Environmental Resources Management

December 19, 2005

RE: Former CEE Associates Limited Partnership Property

80 Pickett District Road (the "Site")

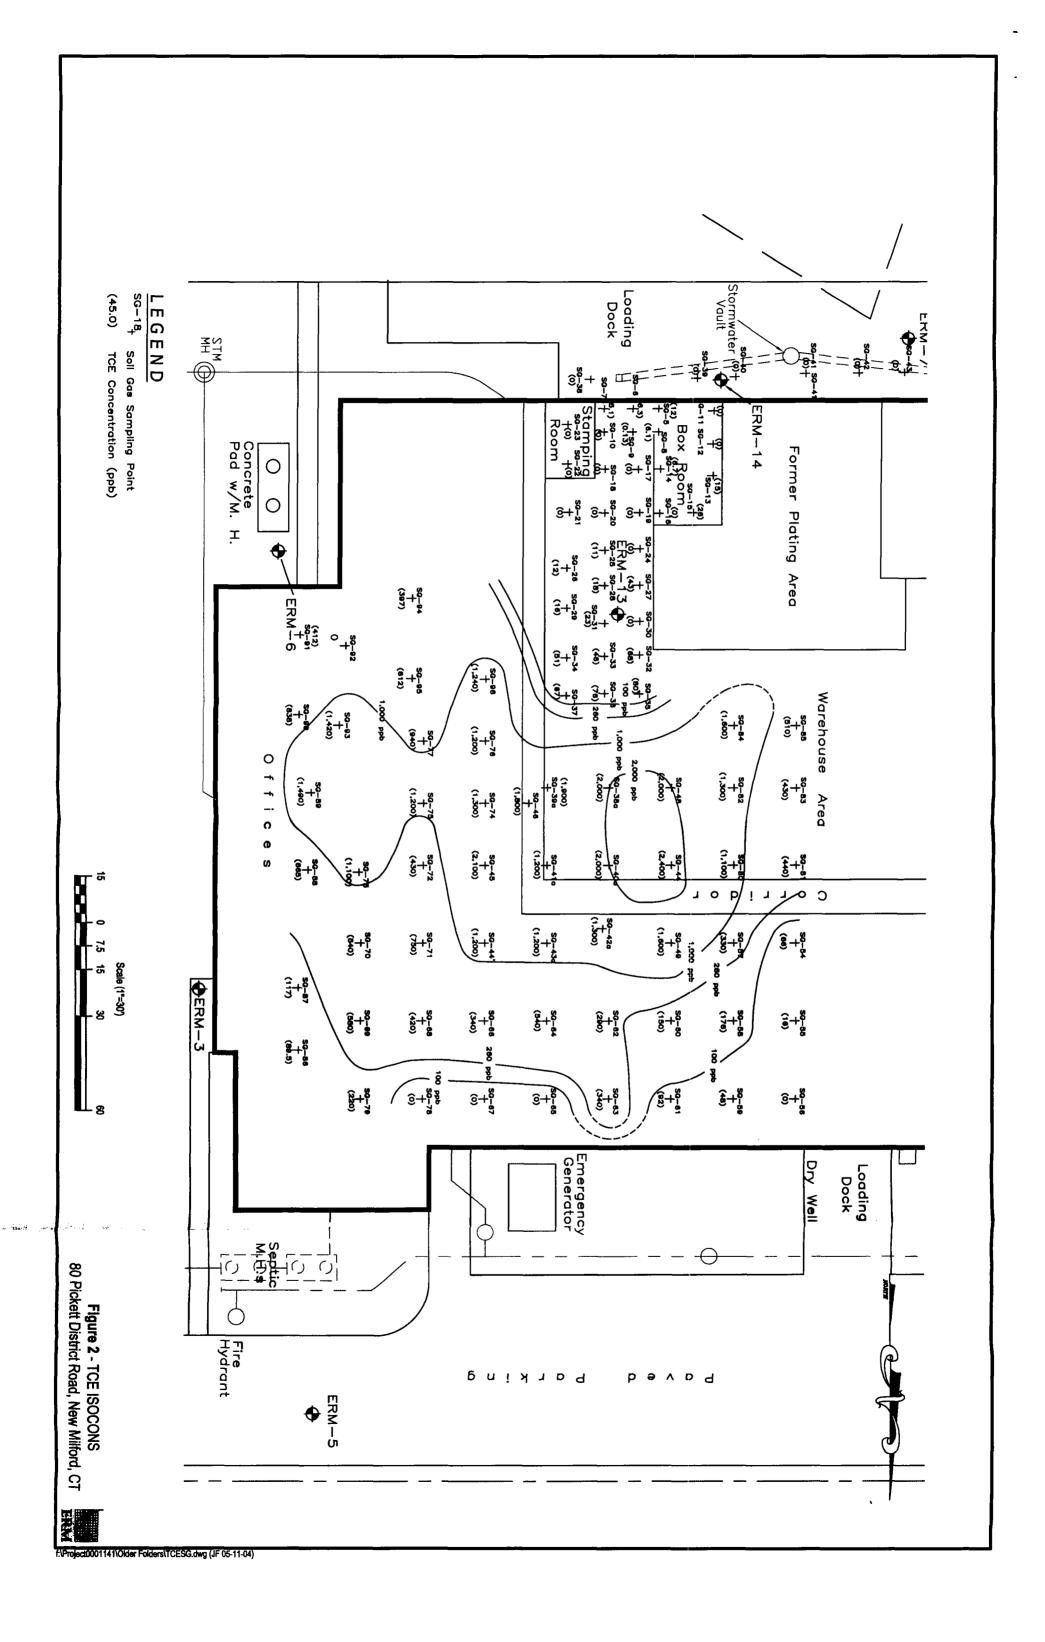
20. Additional Bedrock Groundwater Investigation

ERM plans to prepare a cross-section of the overburden materials on the Site to be included in the next Annual Report. It is attached for your immediate review.

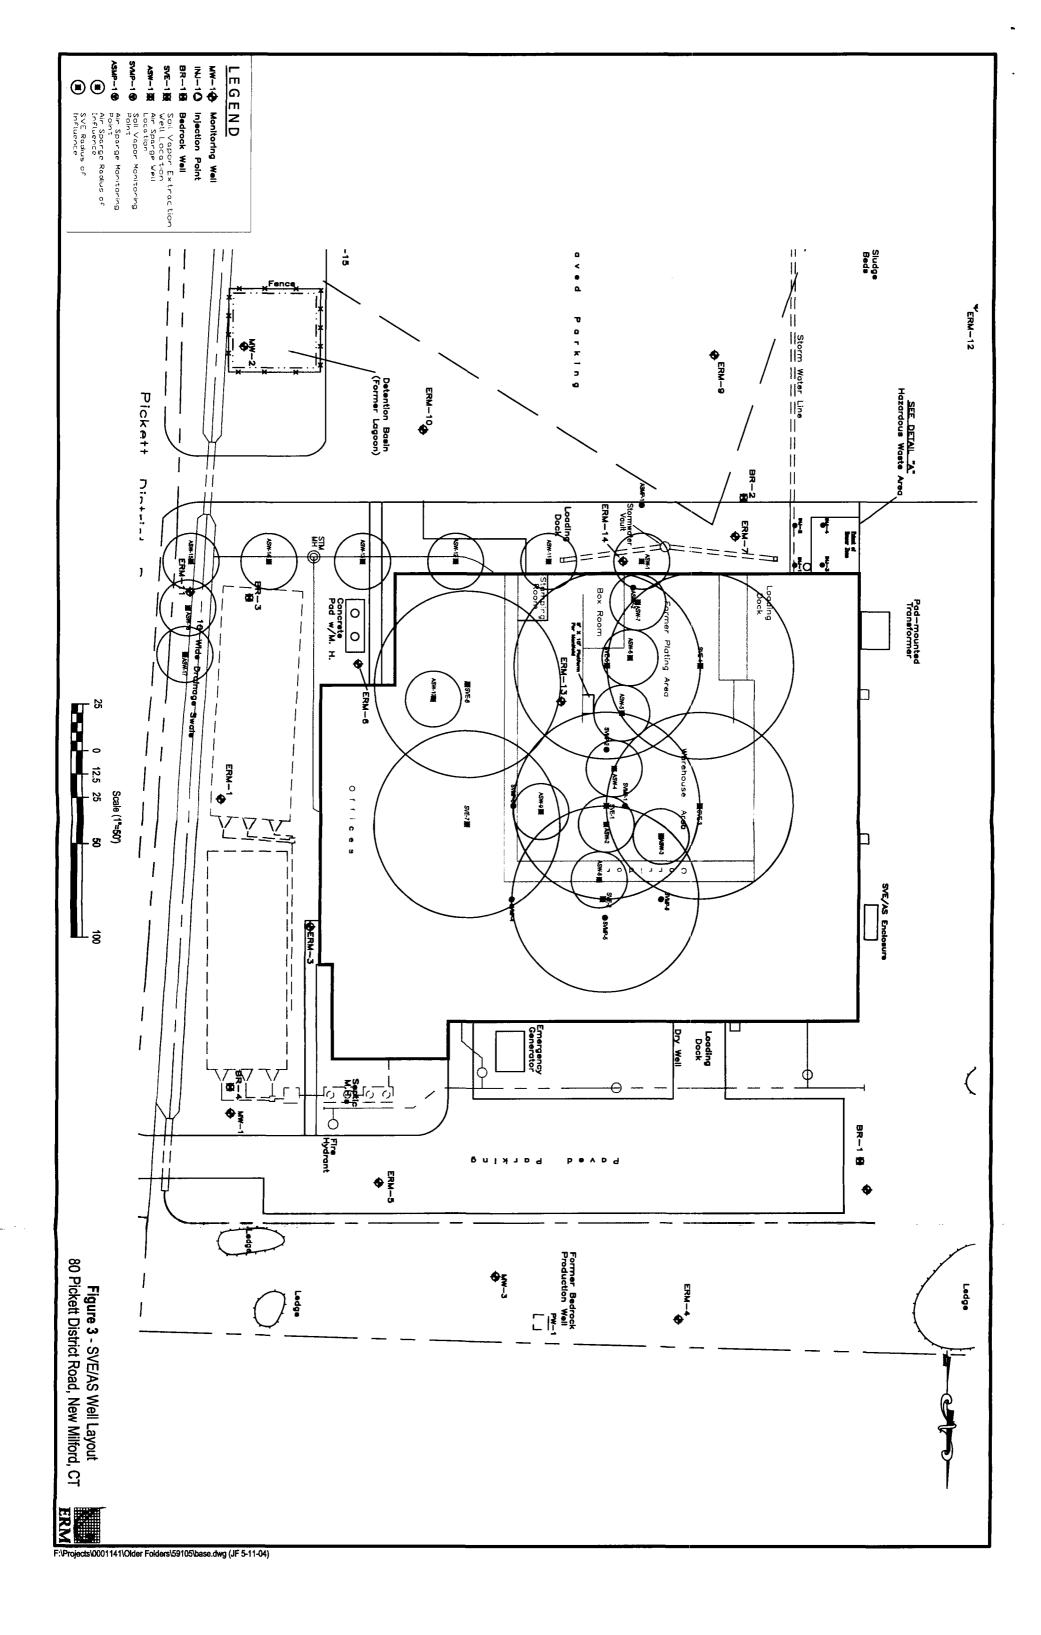
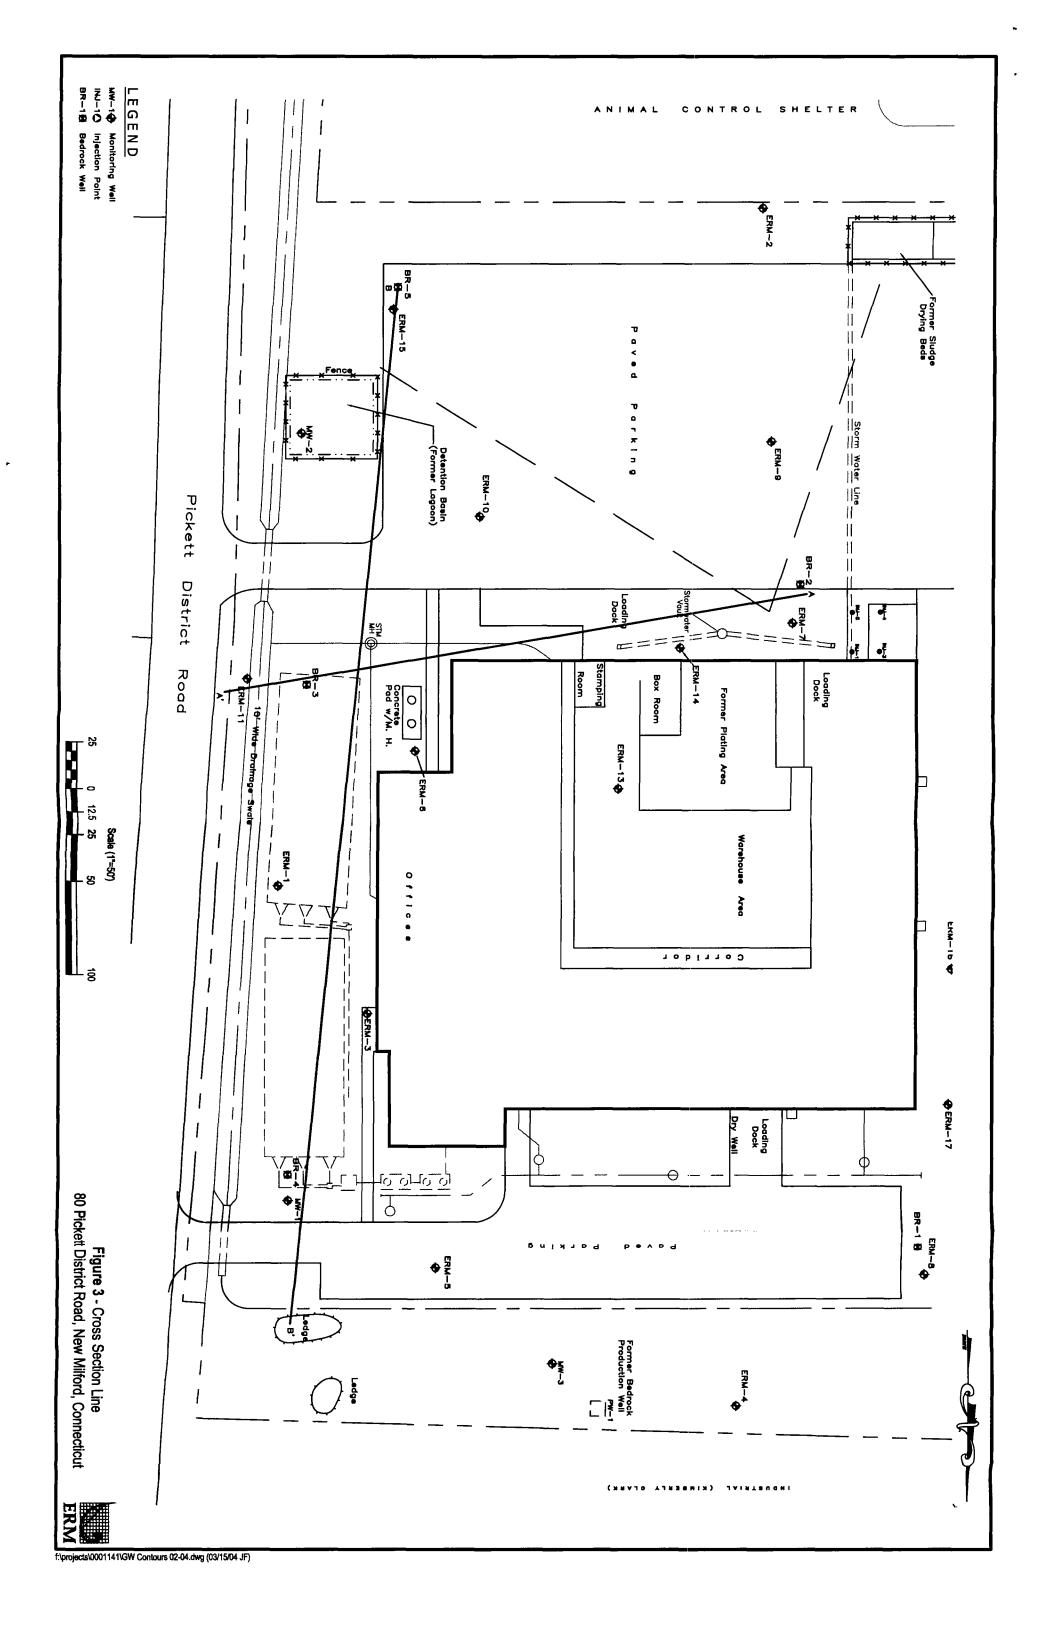
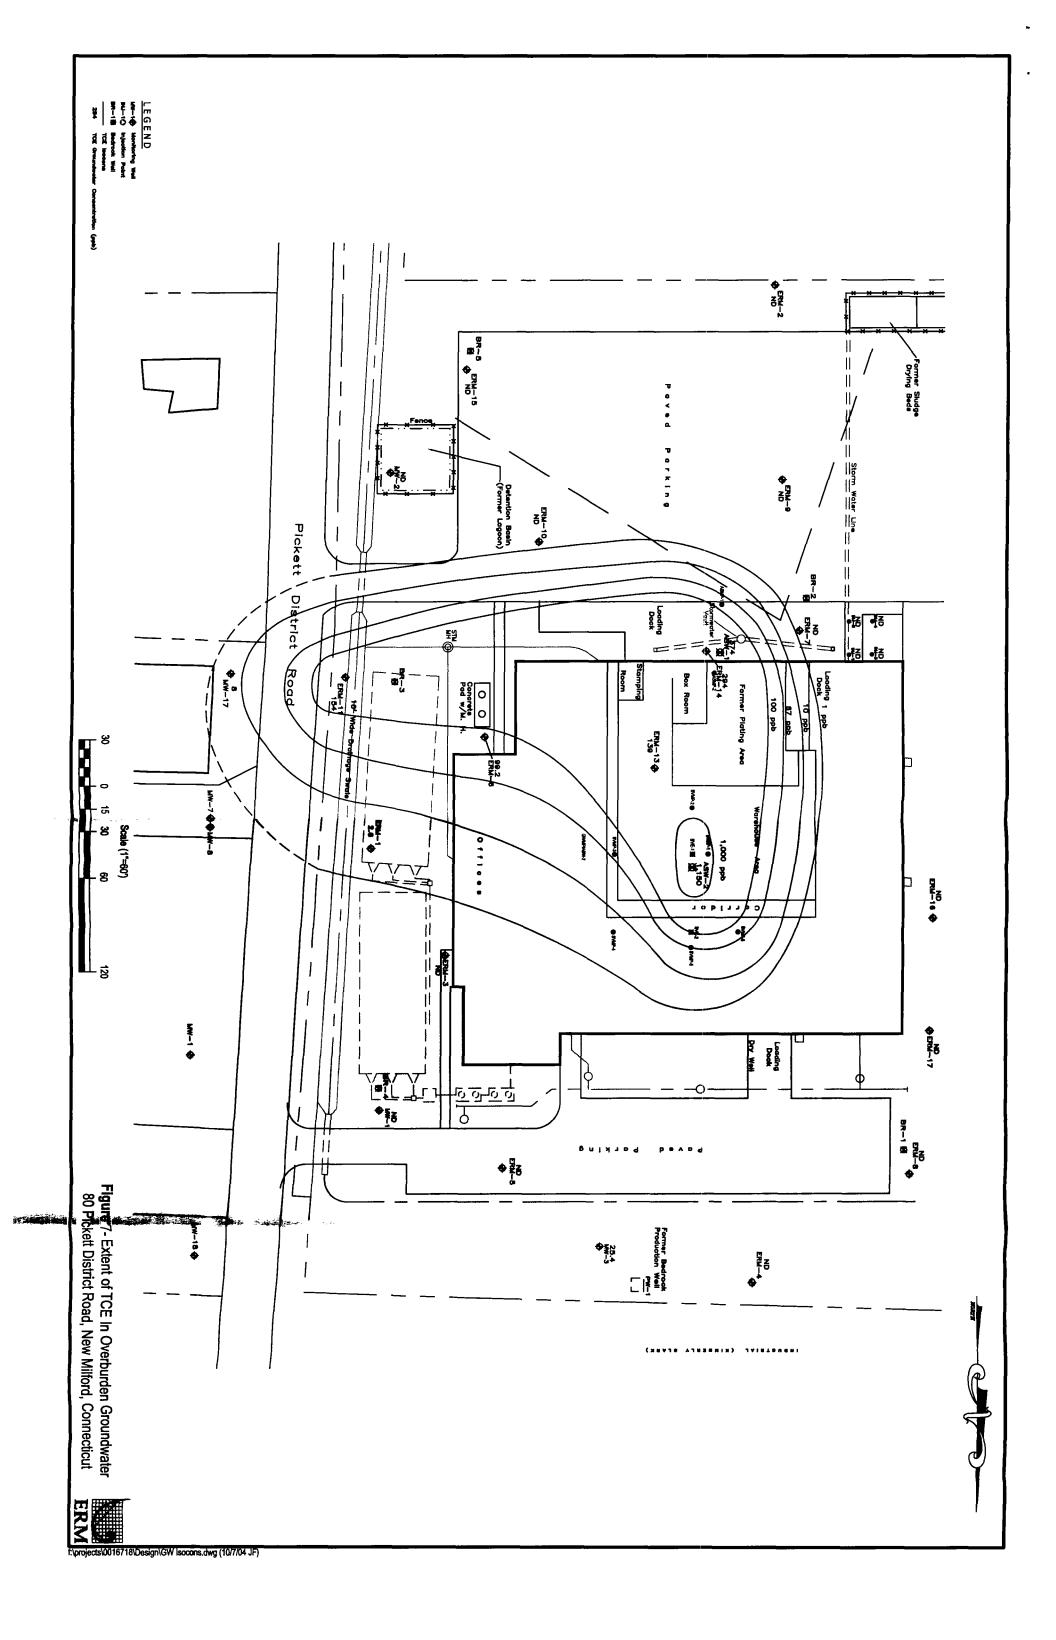
8. Section 2.5 Revisions to Conceptual Site Model

14. Appendix E, Pilot Study Work Plan

observed through a review of the layout of the air sparge points within and adjacent to the building (see Figure 3, from AS/SVE Design, attached).

The locations of all existing/proposed AS and SVE points are included on Figure 3 from the AS/SVE Design (attached).
